Comhairle Chontae Atha Cliath Theas

Record of Executive Business and Chief Executive's Order

Reg. Reference: SD22A/0081 **Application Date:** 21-Mar-2022
Submission Type: Additional **Registration Date:** 31-Aug-2022
Information

Proposed Development: Relocation of the existing Clondalkin RFC grounds at Gordon Park to new lands at Kingswood Farm, Moneenalion Commons Lower Clondalkin and comprising of 4 new rugby playing pitches, including a high quality main competition pitch (with modern directional floodlighting comprising 18m high floodlighting columns either side) and a high quality Junior pitch both laid approximately level, and two back pitches as well as various grassed rugby training areas all laid on existing land cross fall levels; change of use of existing agricultural shed to accommodate new two storey changing facility and storage areas; a new two storey Clubhouse Pavilion with supporting facilities including dressing rooms, physio rooms, coffee dock, committee rooms, members bar and lounge, plantroom and toilets; all associated site development sustainability and infrastructure work including connection to existing public foul sewer, SUDs, sedum roof and PV roof pan

Fig.8: 'Members Bar' First Floor Area Calculation

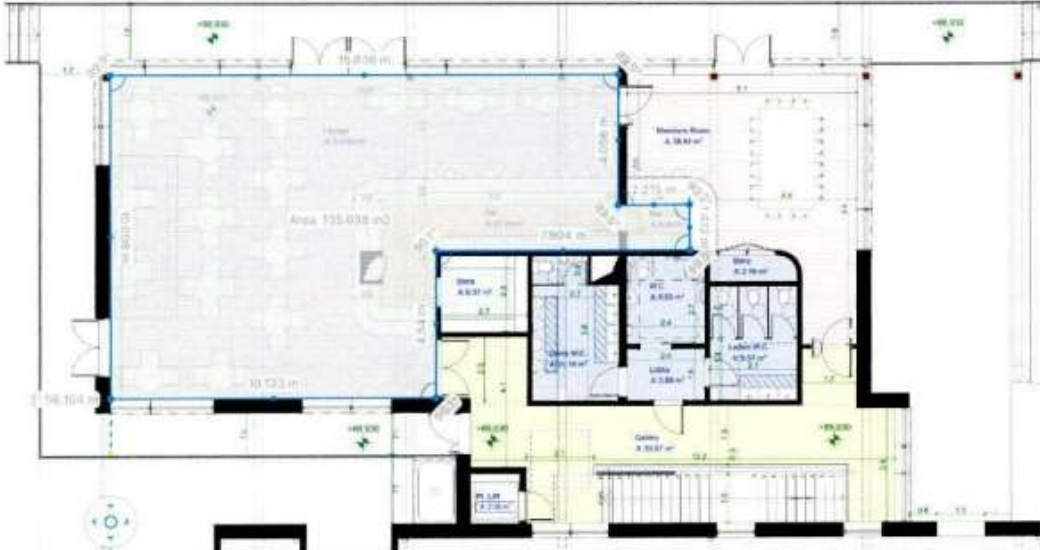
(a) The application includes the provision of a Member s Bar. For 'RU' zoning a public house which is defined as 'A building or part thereof or land licensed for the sale of intoxicating liquor to the public for consumption on the premises', is Open For Consideration but only in Villages to serve local needs. The proposal does not include a justification for the Members Bar in the information submitted to the Planning Authority. Therefore, the applicant is requested to submit information demonstrating a clear justification for the Member Bar.

portion of the Changing Rooms Building and Clubhouse Pavilion together. So, it is of a relatively small scale which is as it such be being ancillary to the proposed overall Sports and Recreational Facility use.

A Rugby Club is not just about the physical activity of playing rugby and being physically active, it is much more than that. It is a team sport, involving mens, womens and juvenile teams covering all age groups and as such building bonds between players and the wider club membership is very important. This is especially true as there are many Members, such as older retirees, ex-playing members, retired referees, Member's spouses and parents of the juveniles, etc who make valuable contributions to the Club and frankly these is no better way for the wider membership to get to know each other than in the convivial atmosphere of the clubhouse after a hard victory or loss. Indeed, its arguably that the real success of Clondalkin RFC over the last almost half-century has been the social bonding of a wide range of Members who have met and become friends over the years. People from the local environs of Clondalkin, Tallaght, Newcastle, Rathcoole and Saggart and further afield, as well as from all backgrounds and age groups.
